Access Compliance Report

Public Rights-of-Way

(Curb Ramps)

Intersection ID: N/A	Main Street: INDEPENDENCE_BV	Cross Street: N/A	Location: S
ADA ID: 3DBBACDF1AA8	Ramp Type: Perp	Initial Pass/Fail: Fail	Overall Compliance: No
		Severity Score: 25

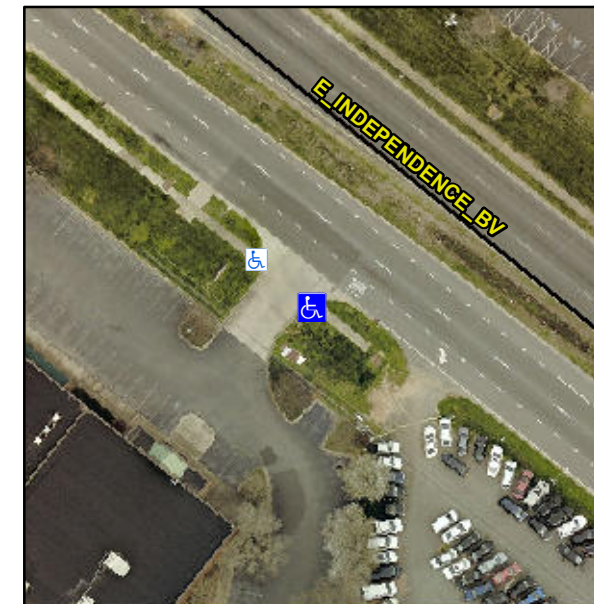
Not Found, R304.5.3

Compliance	Description	Data	Compliance	Description	Data
N/A	Ramp Length (in)	47.0	Yes	Ramp Slope (%)	7.2
Yes	Ramp Width (in)	48.0	No	Ramp XSlope (%)	7.8
N/A	Flare Type LT	N/A	N/A	Flare Type RT	N/A
N/A	Flare Slope LT (%)	N/A	N/A	Flare Slope RT (%)	N/A
N/A	Flare Traversable LT?	N/A	N/A	Flare Traversable RT?	N/A
N/A	Landing Length (in)	N/A	N/A	DWS Provided?	N/A
N/A	Landing Width (in)	N/A	N/A	DWS Contrast?	N/A
N/A	Landing Slope (%)	N/A	N/A	DWS Length (in)	N/A
N/A	Landing X Slope (%)	N/A	N/A	DWS Full Width?	N/A
N/A	Landing Curb? (Y/N)	N/A	N/A	DWS Offset (in)	N/A
N/A	Shared Landing?	N/A			
N/A	Gutter Ponding?	N/A	N/A	Gutter Slope (%)	N/A
N/A	Gutter Lip Ht (in)	N/A	N/A	Gutter X Slope (%)	N/A
N/A	Painted X Walk1?	No	N/A	Painted X Walk2?	N/A
	X Walk 1 Direction	To NW		X Walk 2 Direction	N/A
N/A	X Walk 1 Width (in)	N/A	N/A	X Walk 2 Width (in)	N/A
	X Walk 1 Slope (%)	0.0		X Walk 2 Slope (%)	N/A
	X Walk 1 X Slope (%)	5.2		X Walk 2 X Slope (%)	N/A

Remove & Replace Entire Ramp.
